Rebuttal Report for

Michael L. Deas, P.E., Ph.D

Russell Brown, Ph.D

Figure 1. Comparison of simulated Millerton Reservoir profiles for a 1 meter layer thickness (“Orig”) and a 0.5 meter layer thickness (“Refine”)

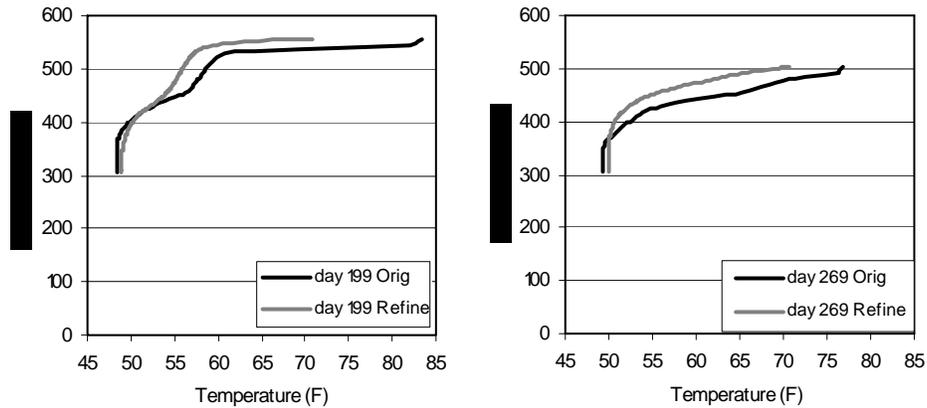
In addition to these identified uncertainties, no discussion of the effect of model spatial resolution is presented. Specifically, no testing of the segment length or layer thickness is presented - the process of incrementally refining the model grid (reducing layer thickness, reducing segment length) while holding all other parameters and conditions constant. Informal testing of the model indicates that reduction in layer thickness from

1.0 meter to 0.5 meters resulted in different simulated profile temperatures (Figure 1). These results are not intended to denote improvement in existing model performance under the refined grid – a recalibration would need to be completed – but that refinement may improve representation of the thermal regime. Although not completed as part of this rebuttal report, refinement of the segment length (longitudinal resolution) is also recommended. These refinements have not been completed due to time constraints.

Figure 2. Simulated Millerton Reservoir water surface elevation (top) and Friant Dam river outlet release temperatures (bottom) for historic, Hanson, and Kondolf proposed Dry-Normal hydrograph: 2003

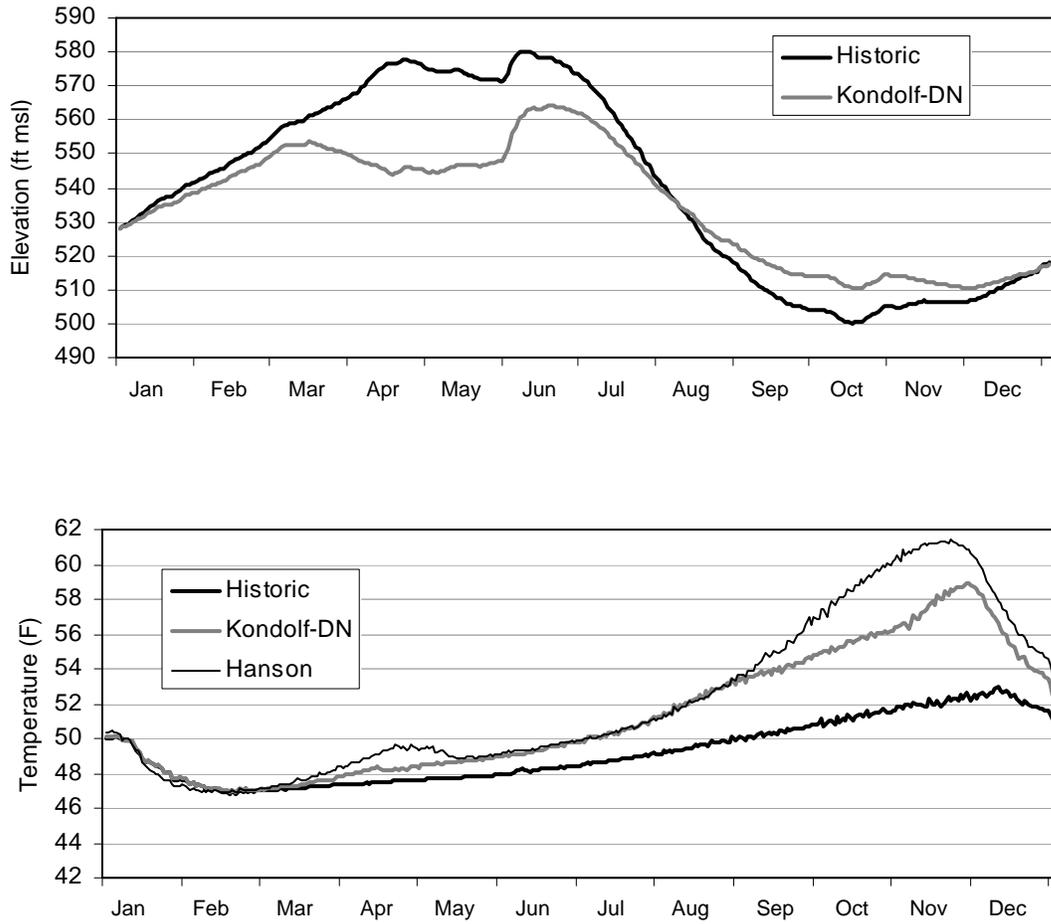
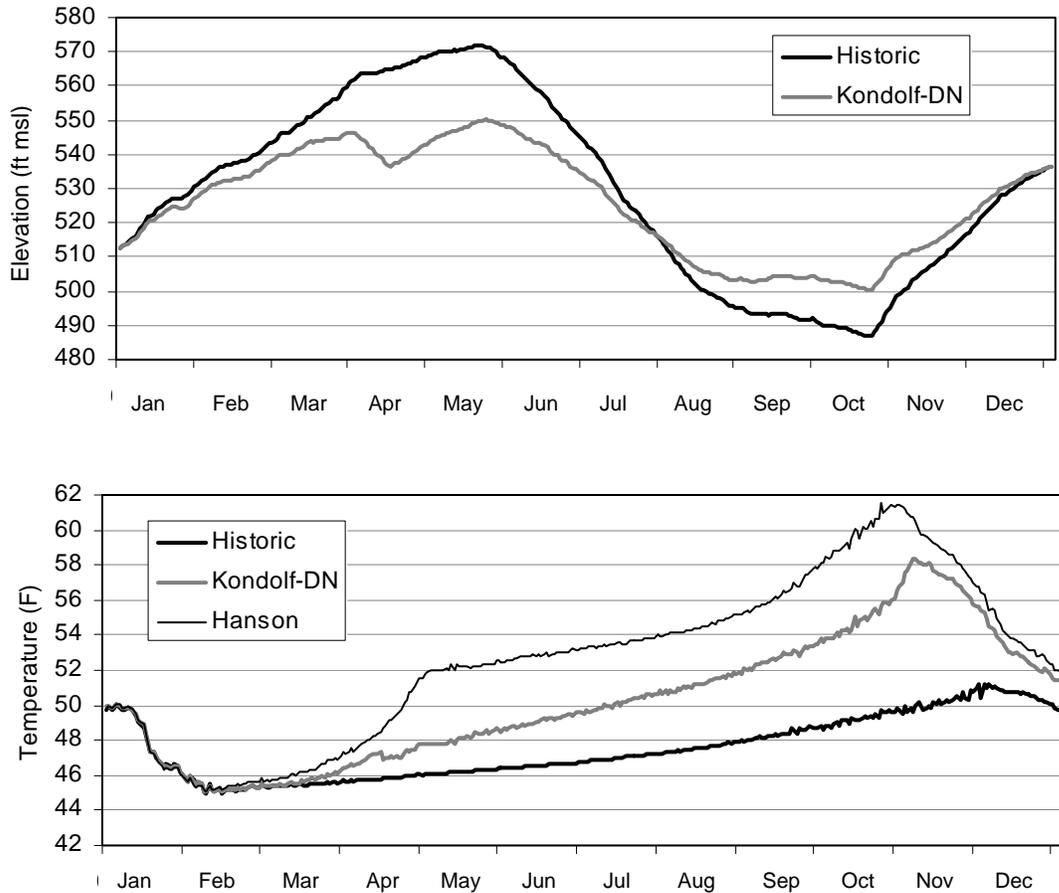
The results show that reservoir storage deviates from the historical case during throughout both years with modest decreases in storage in the January through mid-March period; larger deviations from early spring through early summer as increased river releases reduce storage; and then higher than historic storage through late summer to early winter as reductions in Friant Kern and Madera Canals exceed, on average, increased releases from the river outlets (Figures 2 and 3).

Water temperatures at the river outlets deviates from historic, with temperature higher than historic from Mid-March onward. Temperatures peak in the November period as cool water supplies are diminished. This diminished cold water supply is within Millerton Reservoir proper, as well as the possibility of upstream storage sources running

low on cold water as well. Maximum temperatures for the historic simulation were 53.0°F and 51.2°F for 2003 and 2004, respectively; for Kondolf -DN conditions 58.9°F and 58.4°F for 2003 and 2004, respectively, and Hanson conditions 61.4°F and 61.5°F for 2003 and 2004.

Figure 4. Simulated Millerton Reservoir water surface elevation (top) and Friant Dam river outlet release temperatures (bottom) for historic, Kondolf proposed Dry-Normal hydrograph, and Kondolf proposed Dry-Normal hydrograph with lower initial reservoir storage: 2003

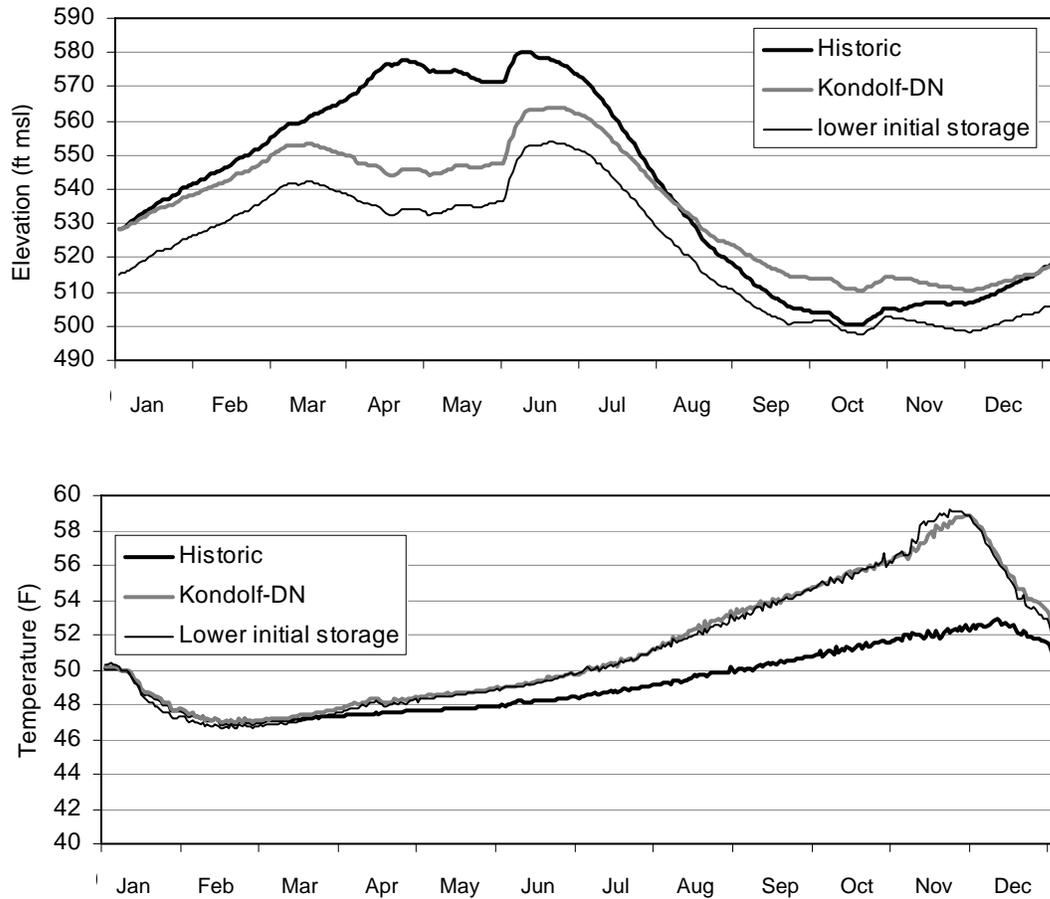
For the two years of simulation data (2003 and 2004) provided by Dr. Brown, the impacts of a potentially lower initial storage, calendar year 2003 was simulated with an initial elevation associated with a reduced storage by approximately 50,000 acre-feet – approximately 515 ft mean sea level (msl) versus approximately 528 ft msl. The calendar year 2003 was selected because Dr. Brown reduced historical initial storage for the Hanson hydrograph simulation by approximately 50,000 acre-feet “based on monthly operational modeling by Daniel Steiner, based on the USAN model” (Dr. Brown Report, pg 14). Thus, this Kondolf DN simulation with reduced initial storage allowed a more direct comparison of the Kondolf DN hydrograph with the Hanson hydrograph. Surface water elevation and Friant Dam river outlet release water temperatures are shown in Figure 4.

Impacts on release water temperatures are nearly the same for the Kondolf DN hydrograph with reduced and non-reduced initial storage throughout the year, with the exception of an approximately two-week period in November where temperatures are increased slightly above the Kondolf-DN year by up to approximately 0.8°F. Carryover

(i.e., initial) storage issues under these conditions are not critical because the initial storage is sufficiently high, and the fall storage conditions under these conditions do not differ significantly from the historical conditions. The reduction in cool water supplies in late fall correspond with seasonal cooling of the reservoir. Thus reservoir temperatures under the 50,000 acre-foot reduction remain similar to the baseline Kondolf DN hydrograph temperatures. The minimum storage level under the assumed lower 2003 initial storage condition was still some 10 feet above the minimum storage condition for 2004.

Figure 6. Simulated Millerton Reservoir Friant Dam river outlet release temperatures for historic, Kondolf proposed Dry-Normal hydrograph, and Kondolf proposed Dry-Normal hydrograph with upstream temperature control curtain: 2003 (top) and 2004 (bottom)

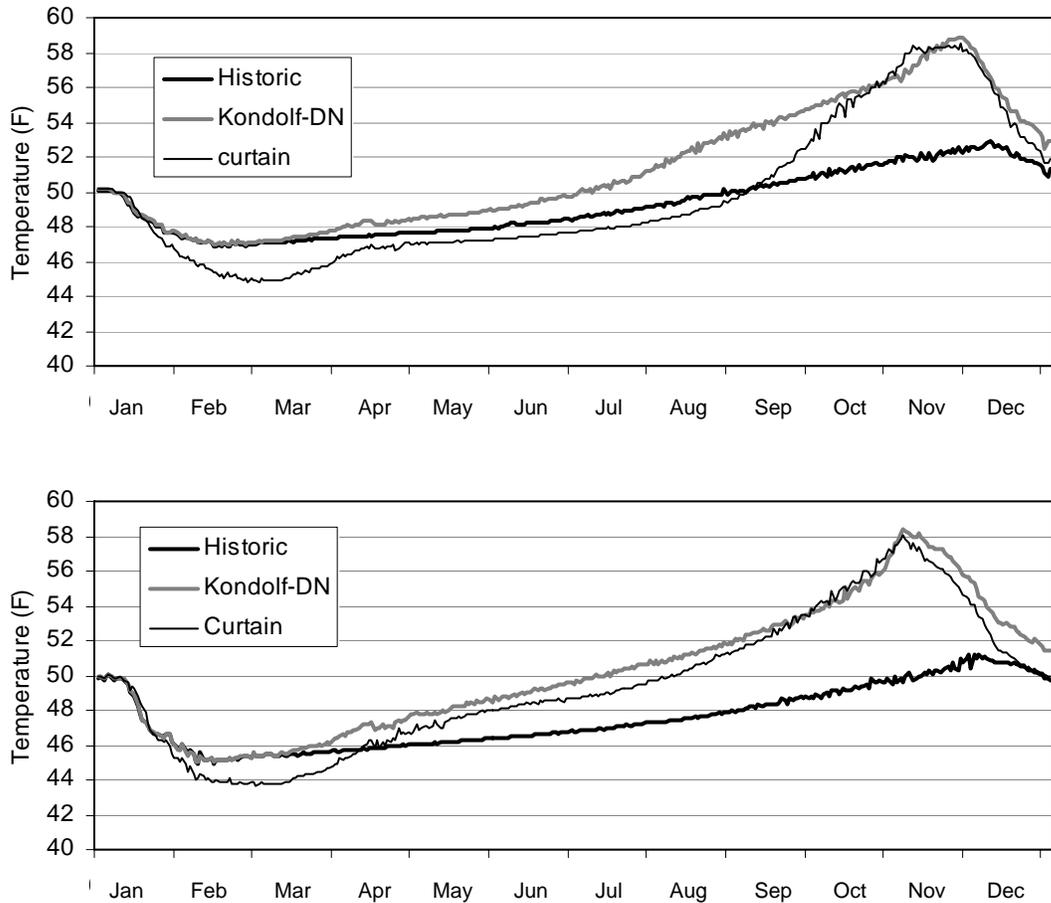
To assess the potential benefits of a temperature control curtain to take advantage of upstream cold water inflow, a curtain was assessed using the submerged weir feature in CE-QUAL-W2. An internal weir was placed in segment 6 extending downward from layer 2 through layer 70. Results, shown for 2003 and 2004 in Figure 6, indicate that there is the potential for considerable difference in temperatures of Friant outflow temperatures. During February, March and April periods, simulated temperatures are notably lower than historic temperatures. Conditions differ among 2003 and 2004 results from April through October. In 2003 river outlet release temperatures are comparable to historic conditions into September, then transition through October to temperatures that are on par with the Kondolf-DN conditions without a curtain in place. Reduced temperatures are more modest in 2004, tracking the Kondolf -DN conditions without a curtain scenario, by up to approximately 1°F lower during summer periods before tracking the without curtain scenario through November 1. For the remainder of the year, river outlet release temperatures for the curtain scenario are warmer than the without curtain scenario by up to approximately 1°F. Though this single curtain analysis represents a simplistic representation of a temperature control strategy, the findings suggest that there is potential for summer temperature control and the possibility for increased potential for cold water management. Additional detailed analysis and assessment of curtain location, size, and operation would allow quantification of thermal and water supply benefits associated with temperature control curtains.

Figure 7. Simulated Millerton Reservoir Friant Dam river outlet release temperatures for historic, Kondolf proposed Dry-Normal hydrograph, and Kondolf proposed Dry-Normal hydrograph with release via Friant Kern Canal and Dry Creek: 2003 (top) and 2004 (bottom)

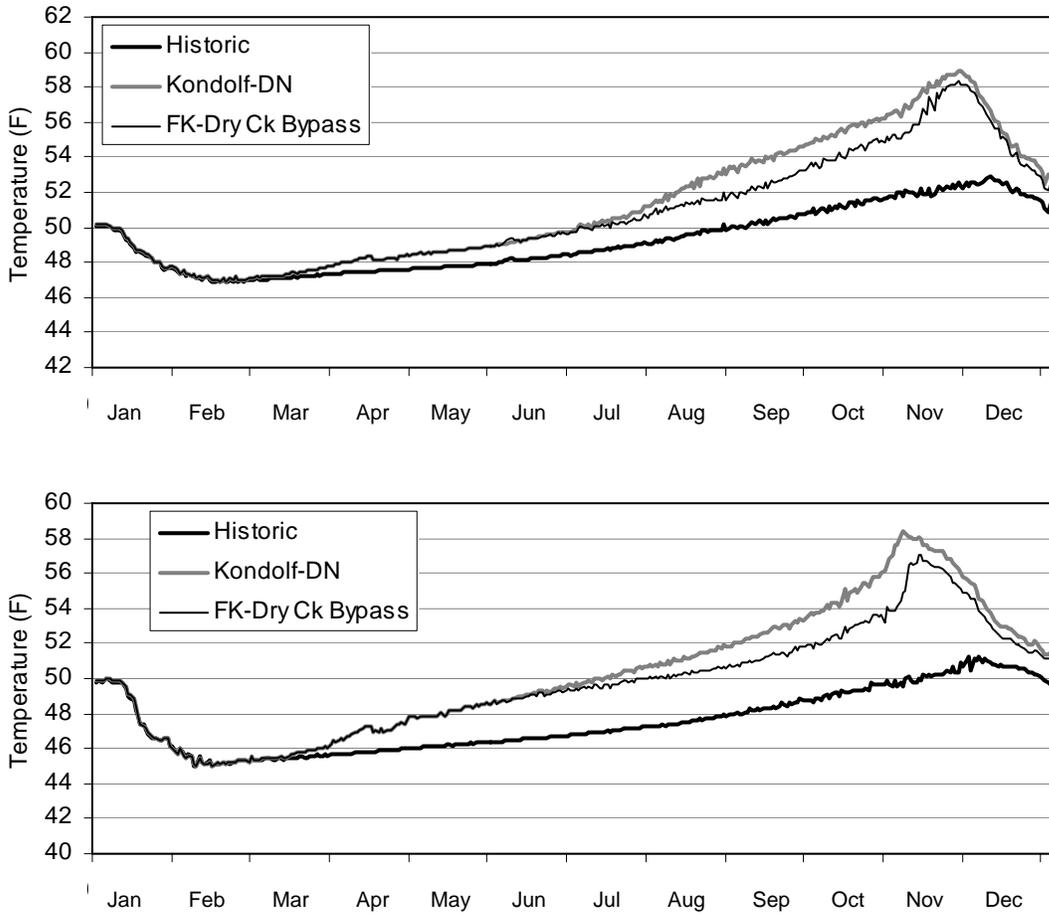
Simulation results indicate that river releases were consistently on the order of 1°F to 2°F cooler through the late summer and fall (Figure 7). Friant Kern Canal release temperatures (at Friant Dam) are appreciably warmer during summer and fall (Figure 8).
